<p>μPD780862 Microcontrollers</p> <p>Technical Update</p>		Document No.	ZBG-CC-06-0055	1/1
		Date issued	December 5, 2006	
		Issued by	1st Solution Group Multipurpose Microcomputer Systems Division 4th Systems Operations Unit NEC Electronics Corporation	
Related documents	μPD780862 Subseries User's Manual: U16418EJ3V0UD00	Notification classification	√	Usage condition
				Upgrade
				Document modification
				Other notification

## Usage Condition Updates in $\mu$ PD780862 Microcontrollers

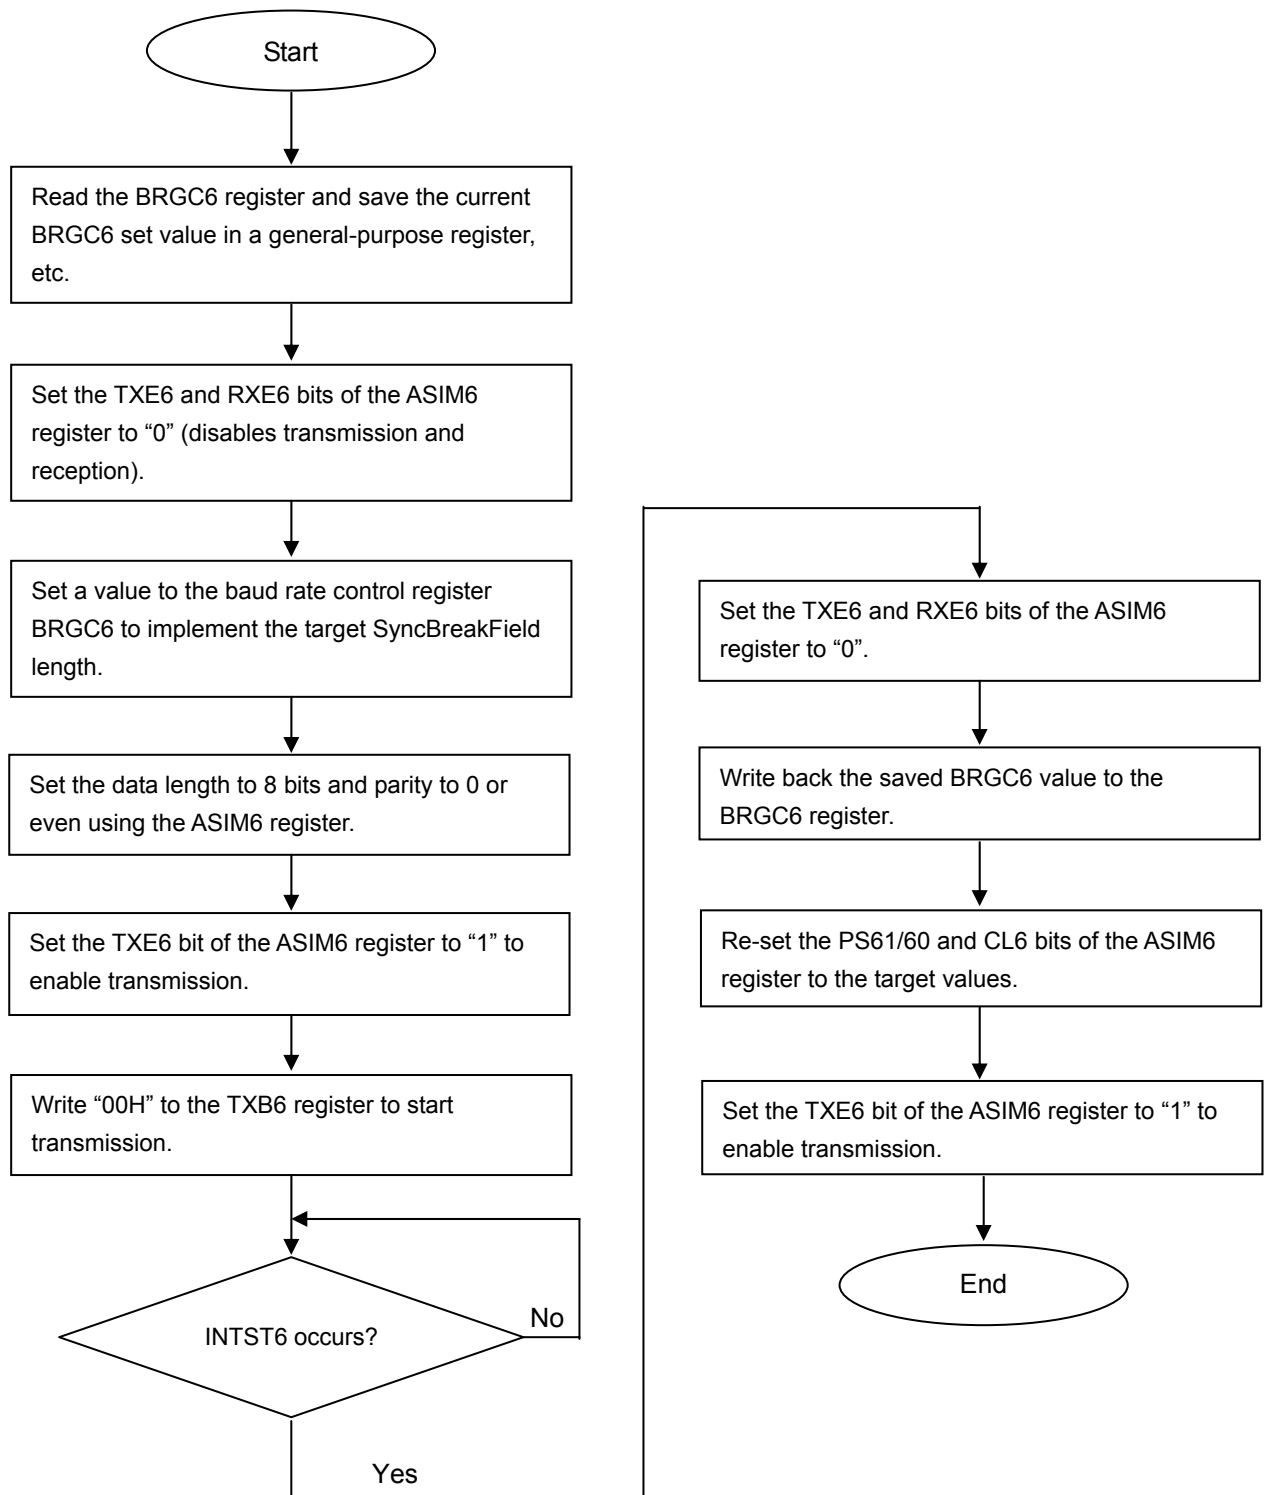
The value set to the baud rate generator control register (BRGC6) to implement the above baud rate value is 130. Therefore, the 13-bit SyncBreakField length is:  $0.2 \mu s \times 130 \times 2 \times 13 = 676 \mu s$

To implement this 13-bit field length in 10 bits, set a value 1.3 times the target baud rate to BRGC6. In this example, set BRGC6 to 169. The 10-bit low-level transmission length is:  $0.2 \mu s \times 169 \times 2 \times 10 = 676 \mu s$

If the setting to the BRGC6 register is not sufficient for setting the bit, also select the UART6 basic clock.

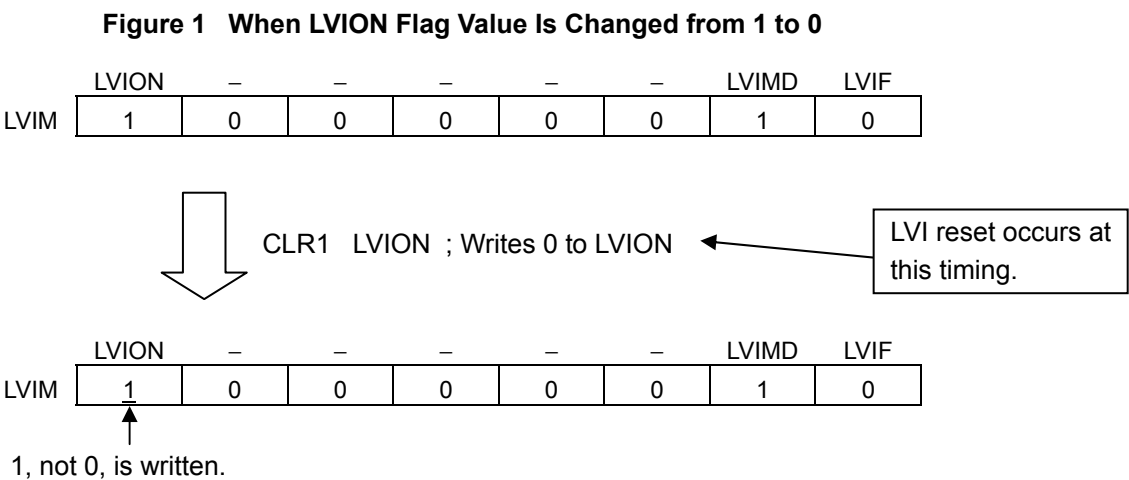
When a reset input by the low-voltage detector (LVI) conflicts with write to a register that sets the LVI operation (LVIM or LVIS), the write-enabled bits of the register may be set to 1. As a result, the following two phenomena occur.

- The reset by the LVI may not stop.
- The voltage detected by the LVI may be lower than the set value or the default value.

Figure 1 shows an example when these phenomena occur due to manipulation of the LVION flag.

In the case of LVIS, the default value (4.3 V  $\pm$ 0.2 V) is detected if bit 3 is set to 1.

- (1) Do not write to the LVIM and LVIS registers after the LVI is set as a reset source.
- (2) Make sure that bit 7 (LVION) of LVIM is 0 before setting the LVIM or LVIS register. If LVION is 1, do not set LVIM and LVIS. By taking this measure, setting of LVIM and LVIS will be performed upon external reset input, POC reset, watchdog timer (WDT) reset or clock monitor (CLM) reset, but will not be performed upon LVI reset.

**Figure 2 Example of Conflict Between LVI Reset and LVIM Register Write**

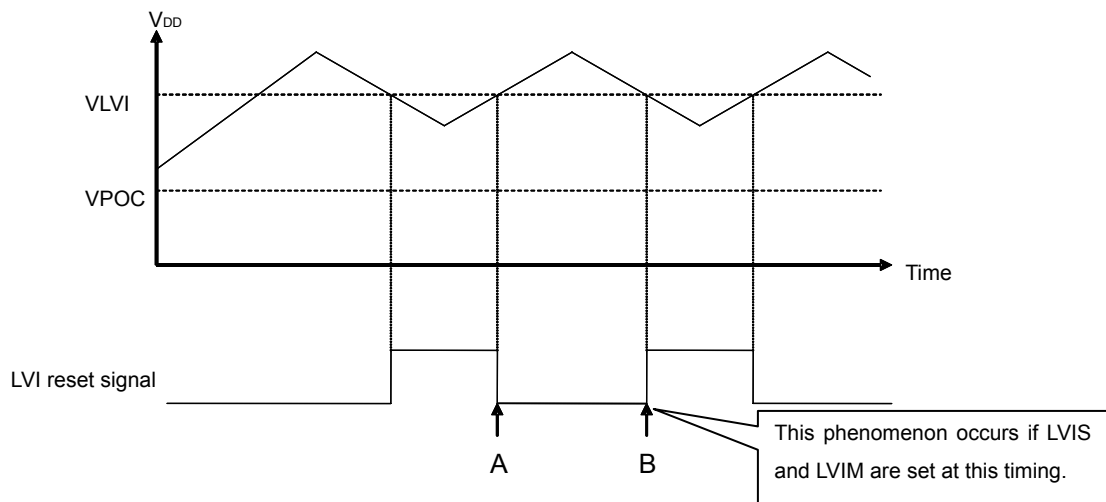
If the VDD voltage varies around the LVI detection voltage (VLVI), the LVI reset occurs several times. In programs in which LVIM and LVIS are always initialized after reset release, if the period from LVI reset release (A in Figure 2) until a LVI reset occurrence (B in Figure 2) matches the time from reset release until initial setting of LVIM and LVIS, this phenomenon occurs.
